Report: Deficiency Report
Function: Test, Adjust, & Balance
Date: 05/19/2025
Completed By: National TAB

05-19-25 WAWA #8196 POTTSTOWN, PA

157 EVERGREEN RD

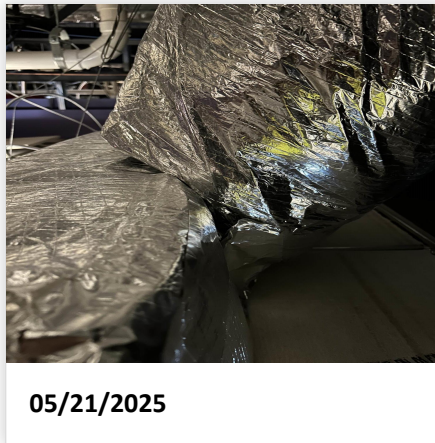
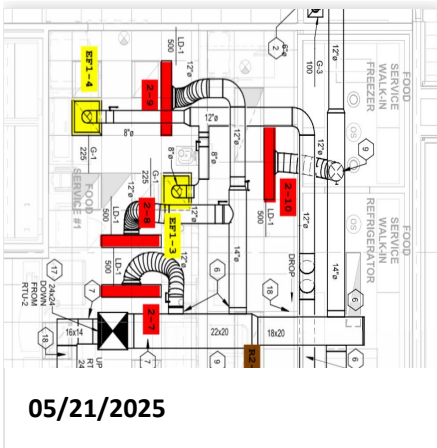
Issue Name : Diffuser 2-10 - Low Flow
Description : Diffuser 2-10 (food service) is currently at 343 CFM (69% design). Damper is fully open. Ductwork appears to be restricted at the diffuser takeoff. All other diffusers for RTU 2 are within design, and further balancing is not expected to improve this diffuser's airflow to design. Recommend mechanical inspection.
Created By : National TAB **Assigned To :** National TAB - Will Turnbough
Status : Open
Priority : High **Asset Tag :**
Originated Date : 05/21/2025 - Mark Johnson - National TAB

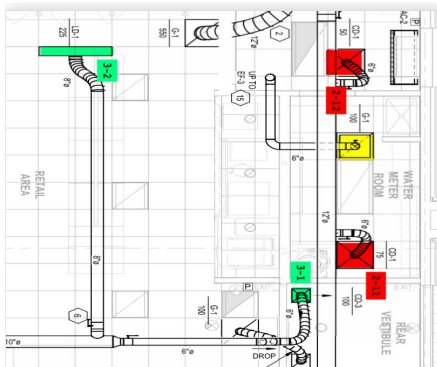
Issue Name : Diffuser 3-1 - Broken Damper
Description : The damper handle for diffuser 3-1 (rear vestibule) was broken while attempting to adjust. Damper blade is stuck inside duct and will not close sufficiently to adjust the diffuser to design airflow. Diffuser is currently at 125 CFM (125% design) and cannot be adjusted further. Recommend damper repair.
Created By : National TAB **Assigned To :** National TAB - Will Turnbough
Status : Open
Priority : High **Asset Tag :**
Originated Date : 05/21/2025 - Mark Johnson - National TAB

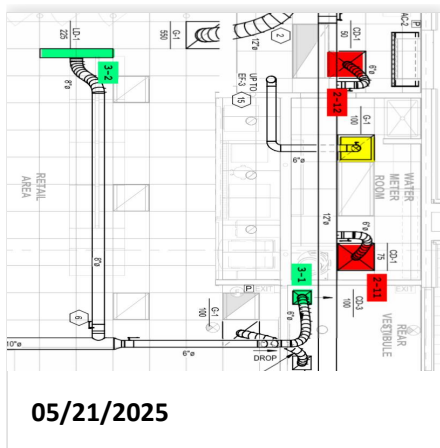
Issue Name : Diffuser 3-2 - Low Flow
Description : Diffuser 3-2 (retail area) is currently at 184 CFM (82% design). Damper is fully open and no ductwork deficiencies were noted. Not anticipated to cause comfort issues in the open retail space; however, it is expected that correcting the damper issue with diffuser 3-1 and closing it to design will improve this diffuser's airflow to be within design.
Created By : National TAB **Assigned To :** National TAB - Will Turnbough
Status : Open
Priority : Medium **Asset Tag :**
Originated Date : 05/21/2025 - Mark Johnson - National TAB
